Work Order ID 105322

Item Name: Aft Crosstube - High

DRAWING NO. REV. E
D412-664-243 SHEET 1 OF 4
TITLE SCALE
CROSSTUBE ASSEMBLY (412 HI AFT) NTS

DRAWING NO. D412-664-243	TITLE CROSSTUBE ASS'Y (412 HI AFT)	REV. E	DART AEROSPACE LTD ENGINEERING ORDER		D.E.O. NO. D412-664-243-E-2	SHEET NO. SHEET 1 OF 1	SCALE NTS
DRAWN 97	CHECKED ASS	MFG. APPR. E	APPROVED MP		DE APPR. H		
DATE 11.09.07	DATE 11.09.19	DATE 11.09.19	DATE 11.09.19		DATE 11.09.19

**D412-664-243
ASSEMBLY DETAIL**

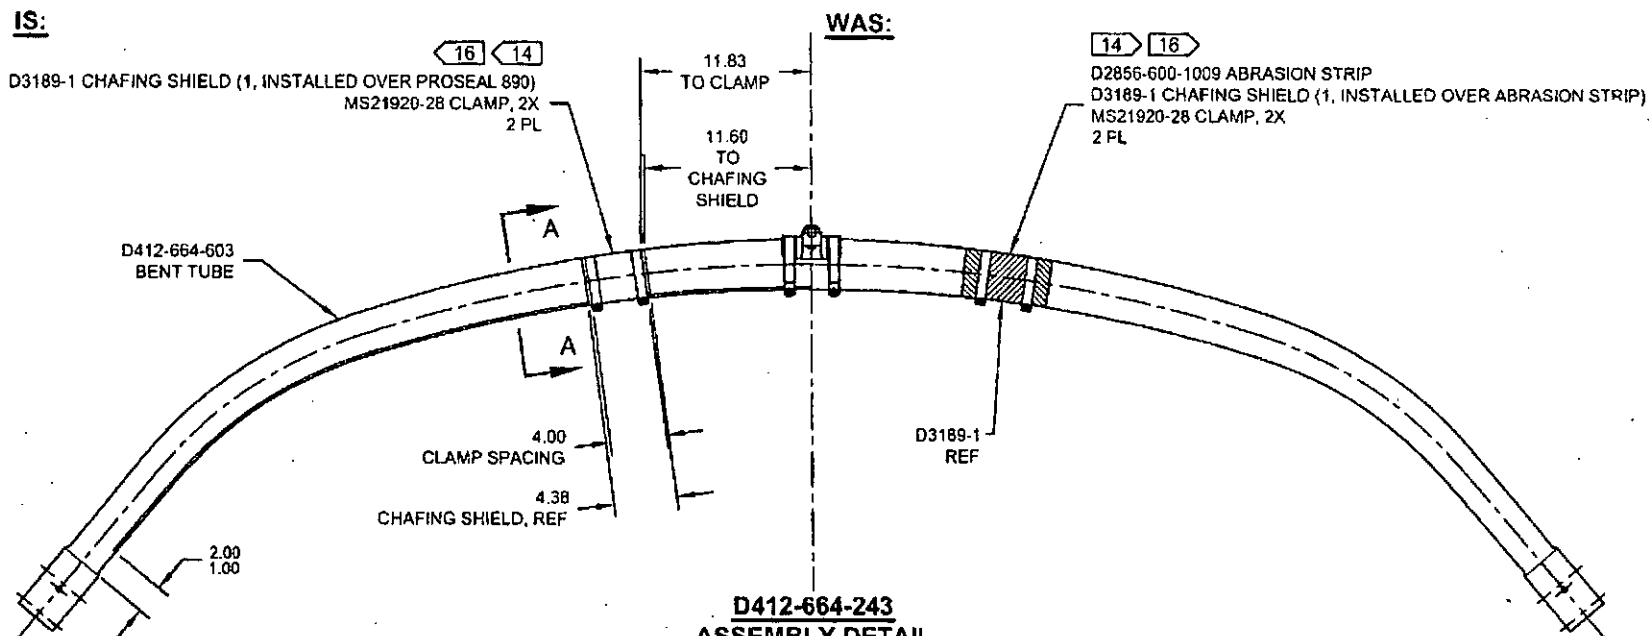
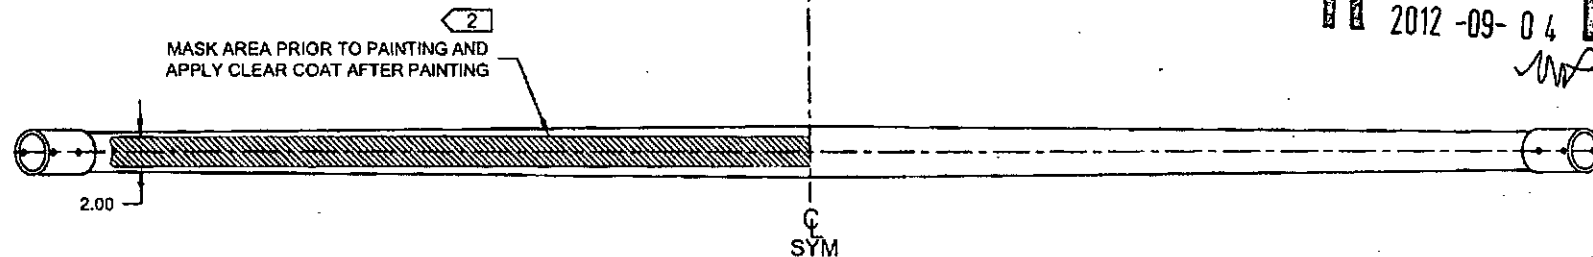
D3189-1 CHAFING SHIELD (1, INSTALLED OVER PROSEAL 890)
MS21920-28 CLAMP, 2X
2 PL

WAS:

D2856-600-1009 ABRASION STRIP
D3189-1 CHAFING SHIELD (1, INSTALLED OVER ABRASION STRIP)
MS21920-28 CLAMP, 2X
2 PL
